Explanation of Request: Site Plan and Design Approval of 500 key hotel

Re: Preliminary Site Plan and Design Review for 500-key Hotel / File No. 23-DP-49/ Applicants' Responses

This response letter is being submitted on behalf of the Applicants, HFL Landings Owner, LLC and Landings Venture, LLC (collectively, the "Applicants") for the Diplomat Landings Site Plan Design review approval for the 500-key hotel. By this letter, we are providing responses to the Preliminary Site Plan and Design Review Committee Report identified at File No. 23-DP-49.

A1.0

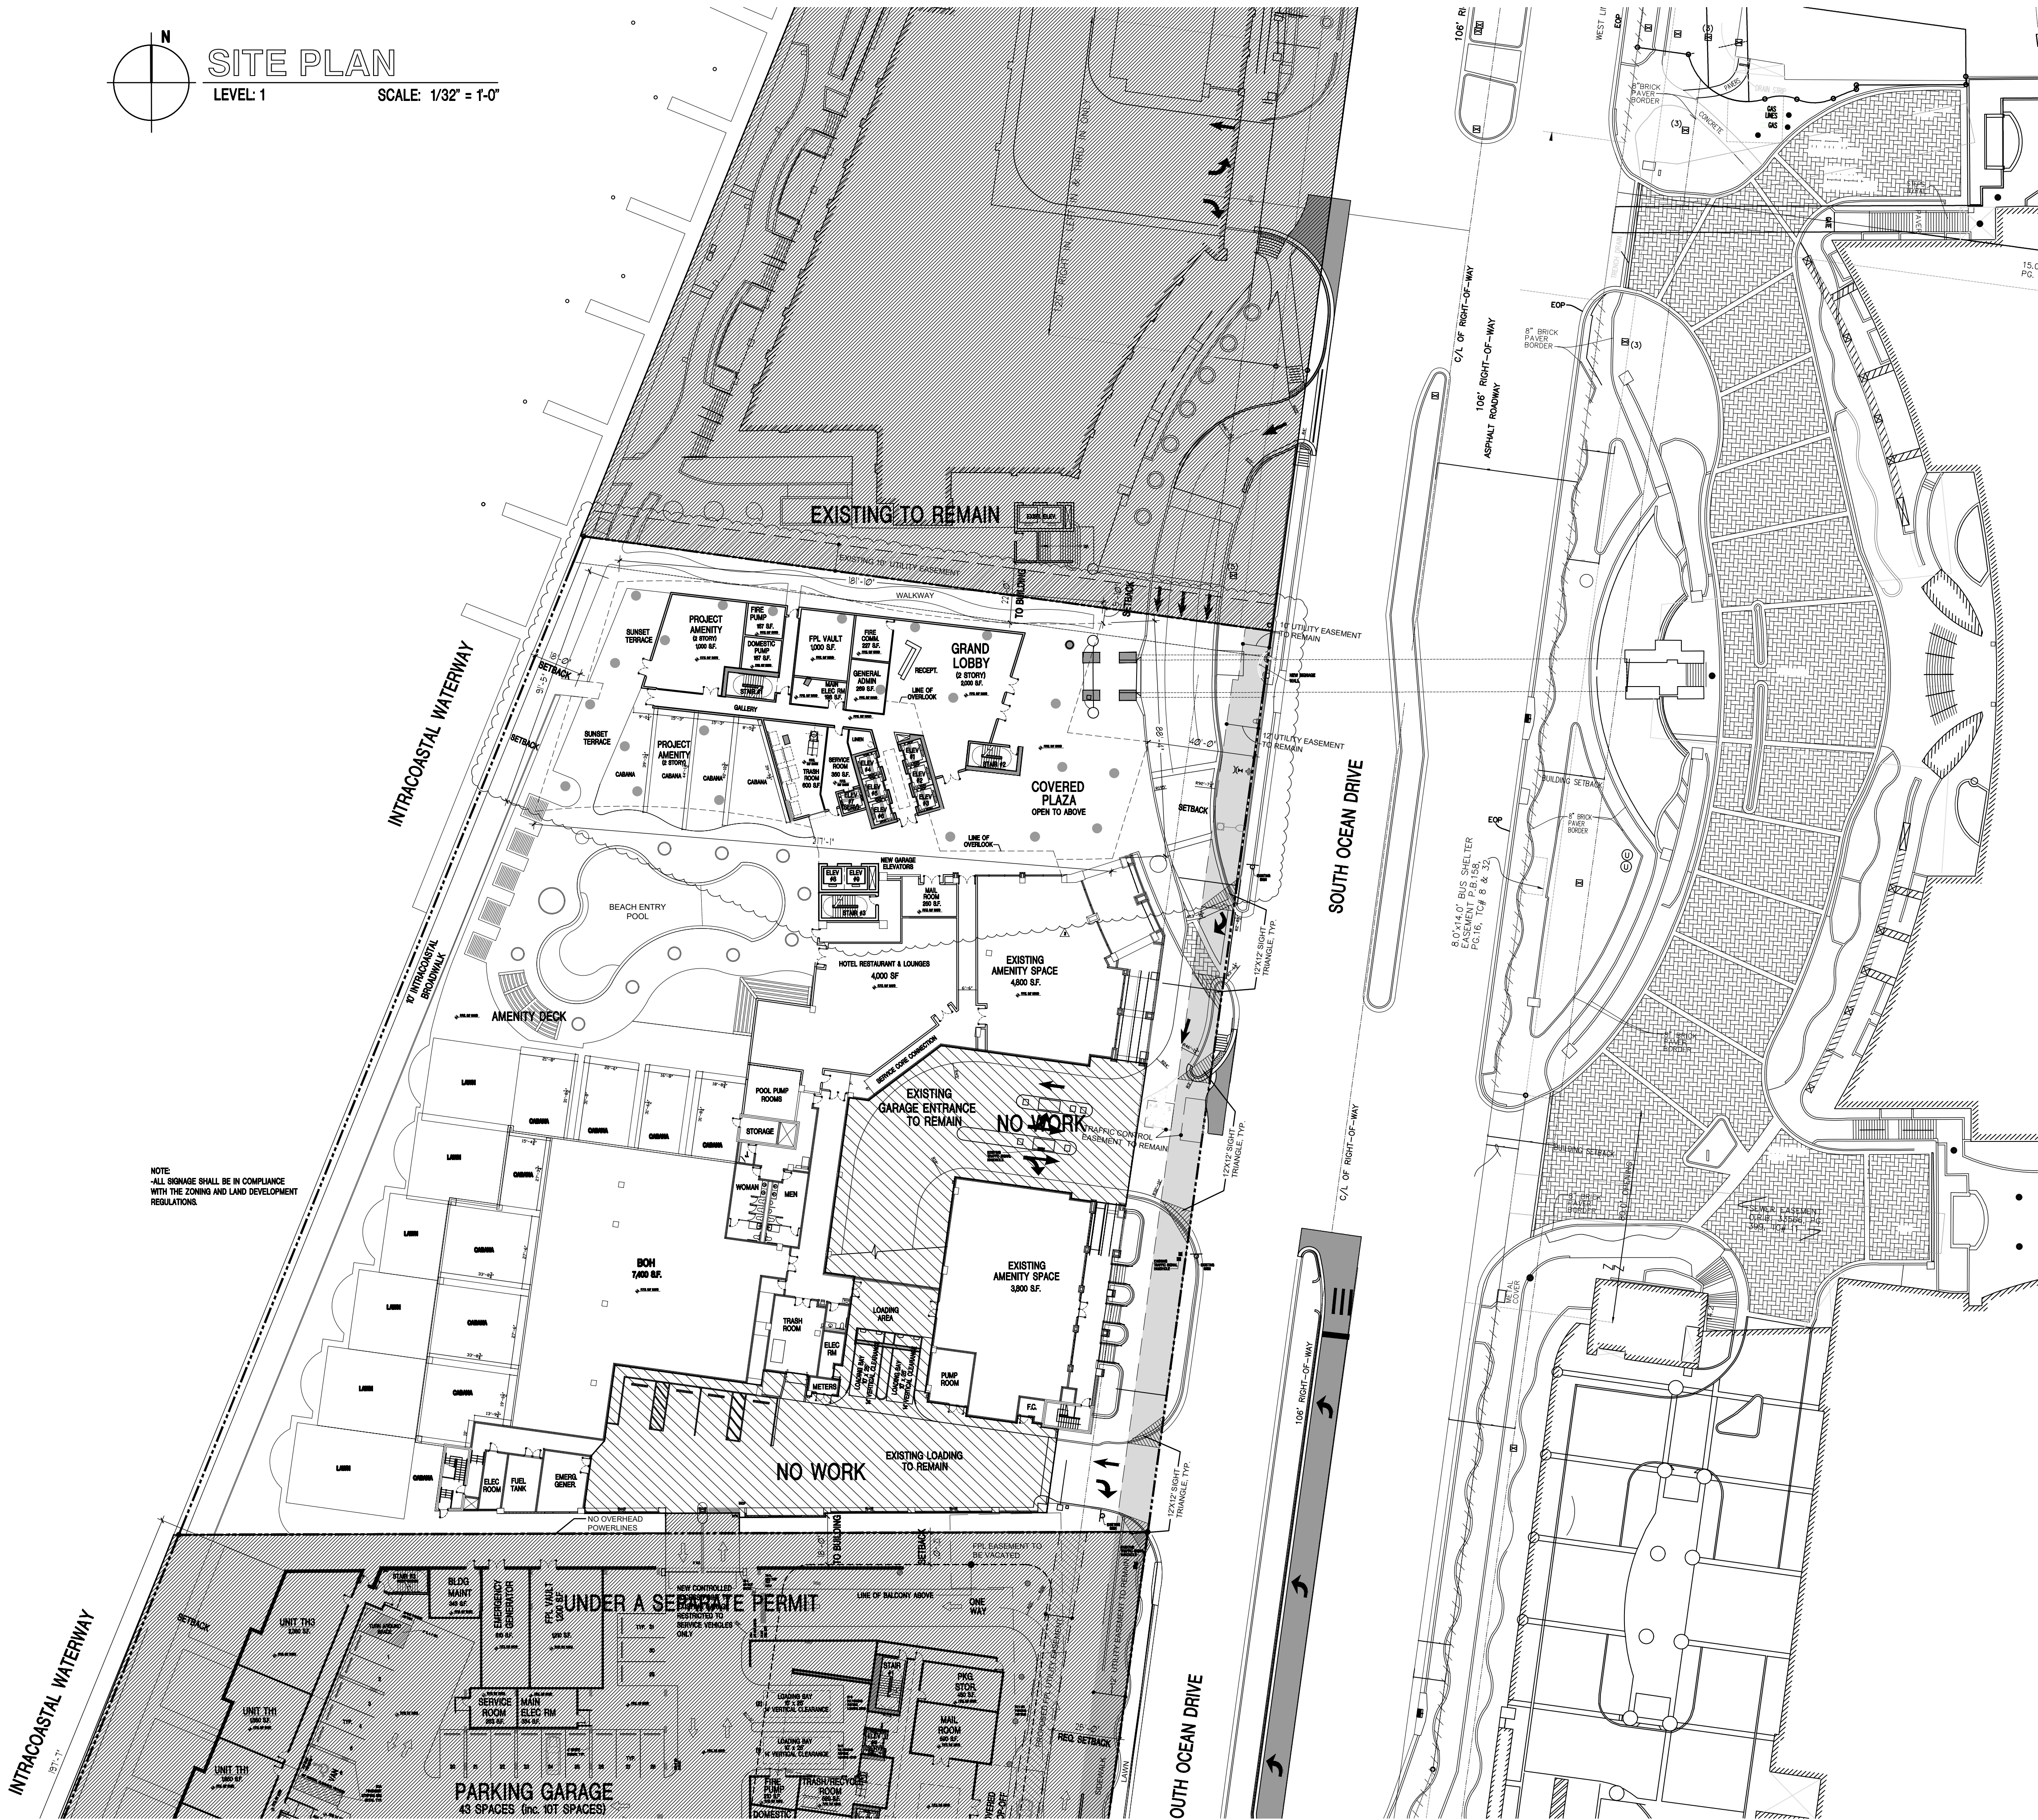
- f. Show dimensions of sight triangles.

1. Sheet A1.0

a. Site illustrations needs to be corrected. It does not indicate the location in context. Add a map to the base of the image.

b. Provide dimensions as appropriate (e.g., cabana area). Dimensions have been provided.

1. Note maximum foot-candle level.

Response: Dimensions of sight triangle have been provided see ground level plans at A1.0

Response: Map has been relocated to the cover sheet.

Response: Dimensions have been provided.

Response: Note has been provided. See sheet A1.0

NOTE:
-ALL SIGNAGE SHALL BE IN COMPLIANCE
WITH THE ZONING AND LAND DEVELOPMENT
REGULATIONS.

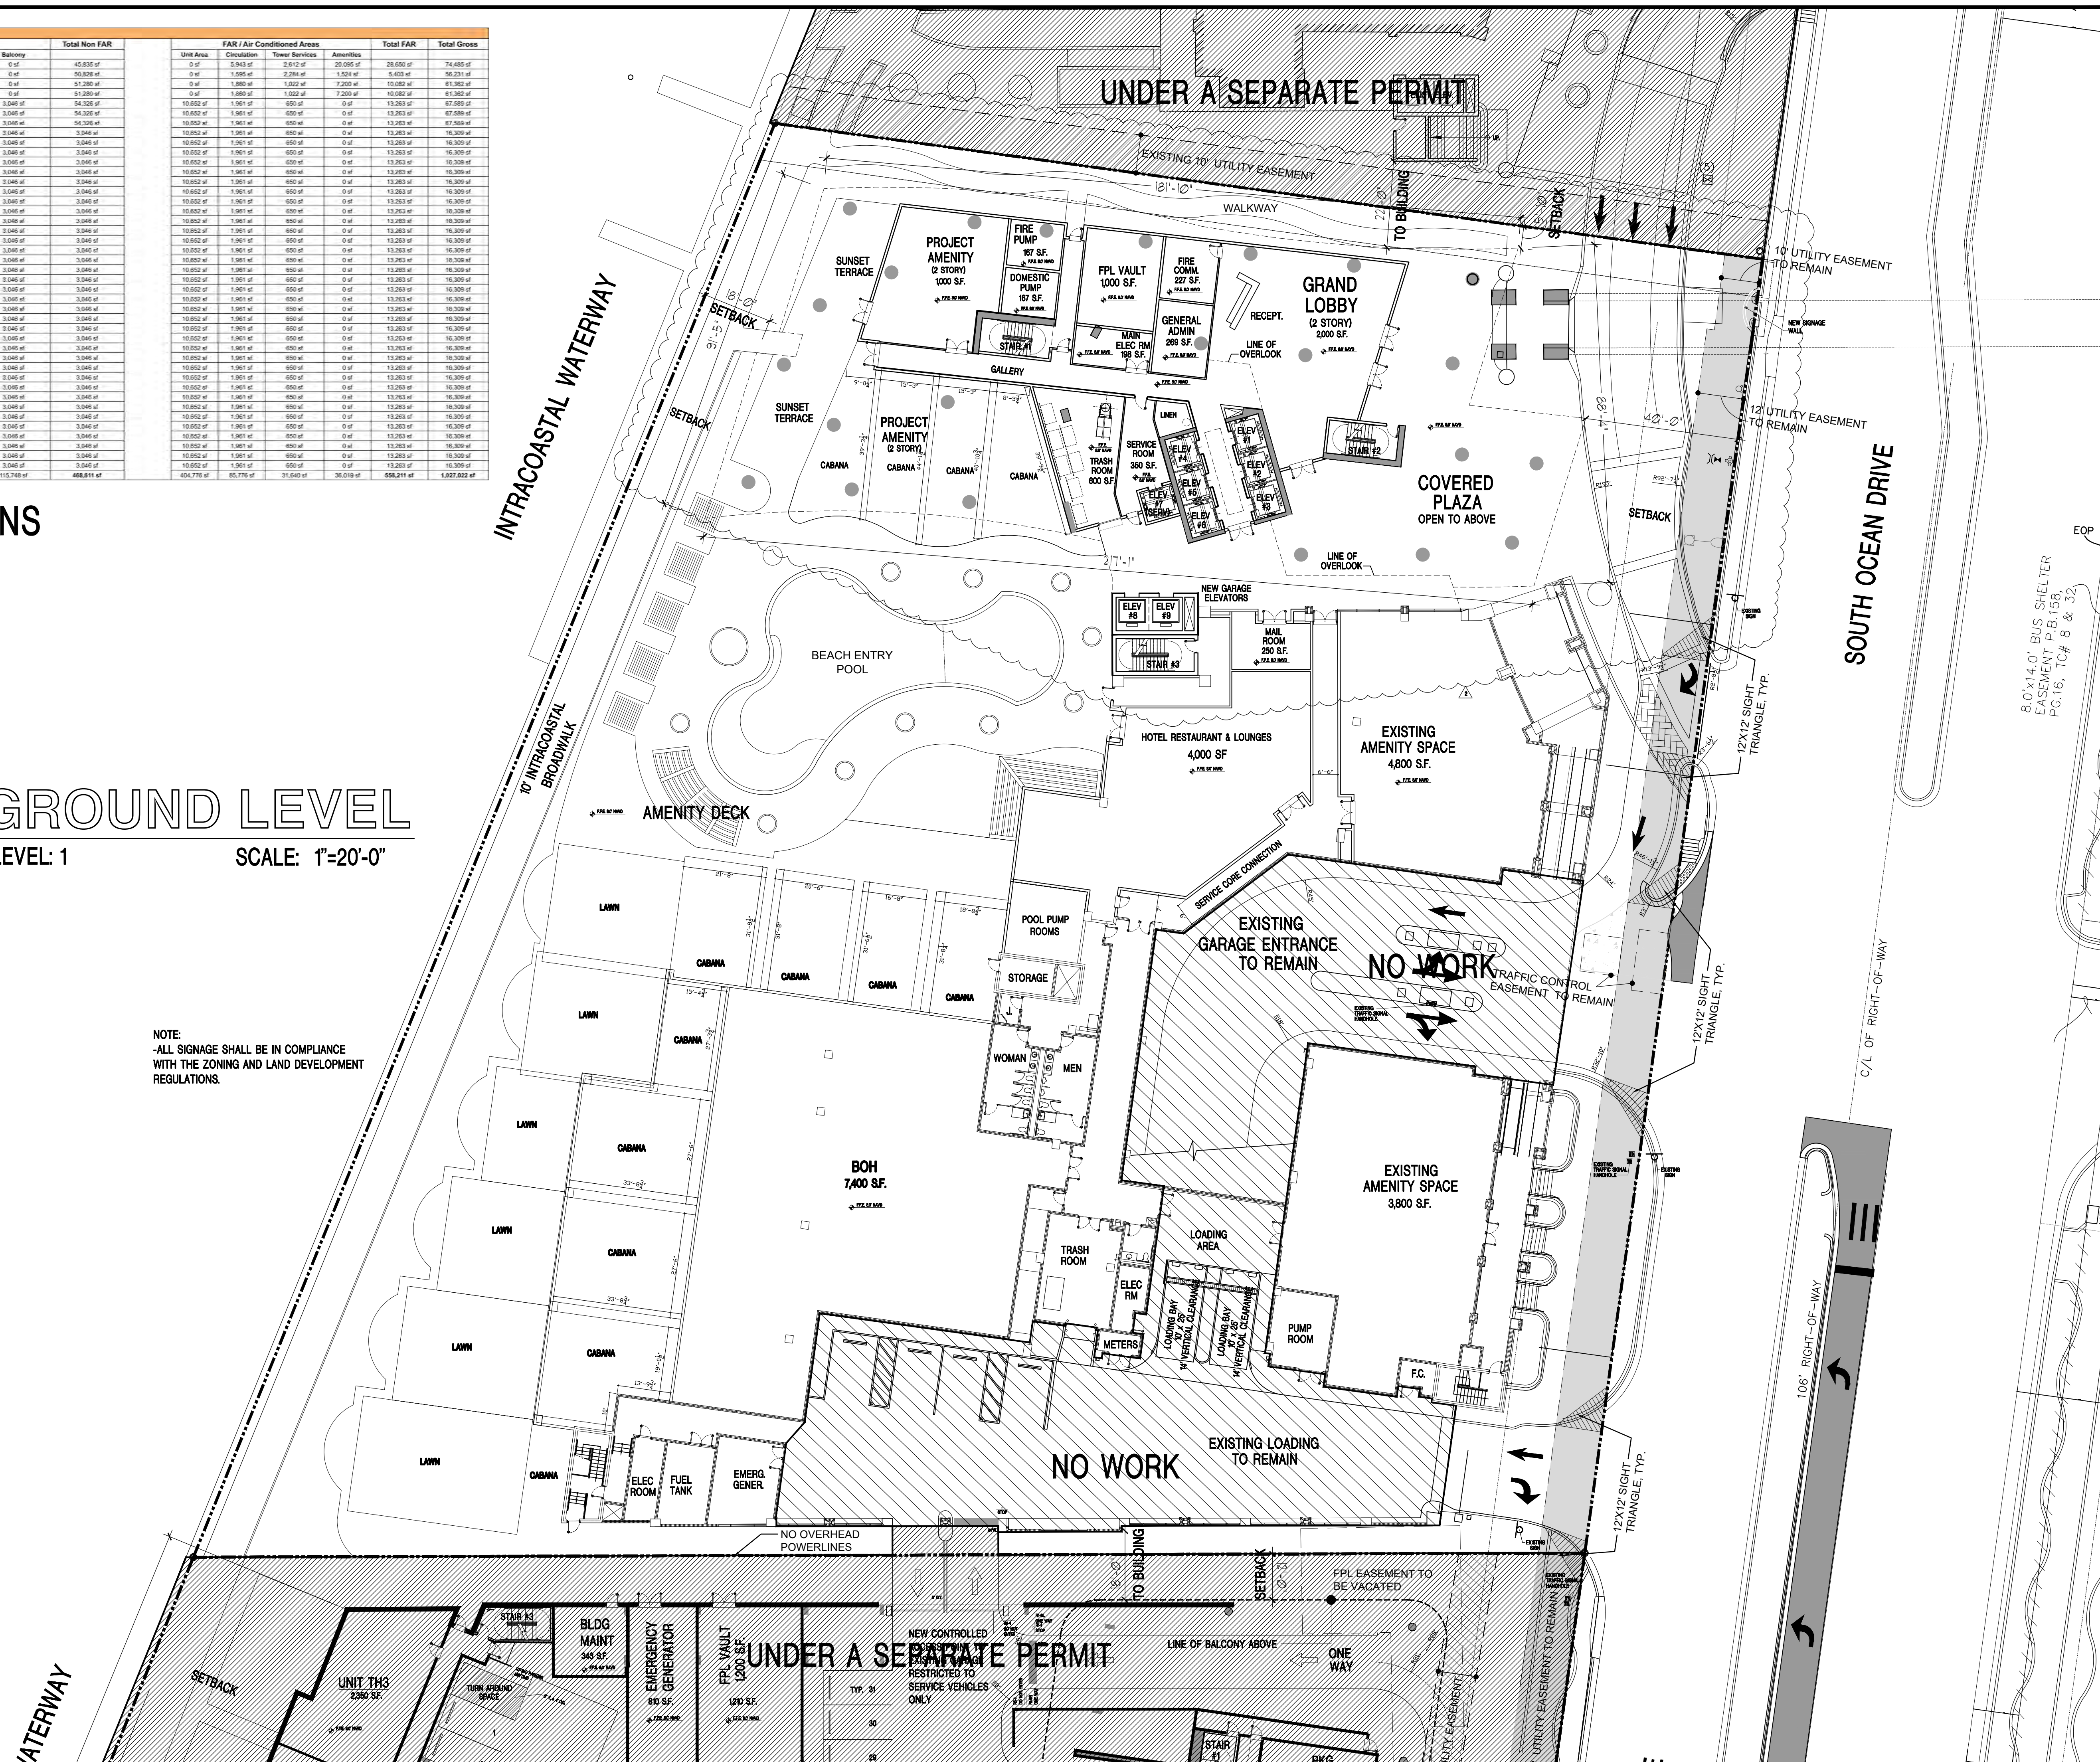
1. Identify location for mail delivery.

3. Include note on Site Plan indicating all signage shall be in compliance with the Zoning and Land Development Regulations.

Response: Mail room has been provided. See sheet A2.0.

Response: Note has been provided. See Sheet A2.0.
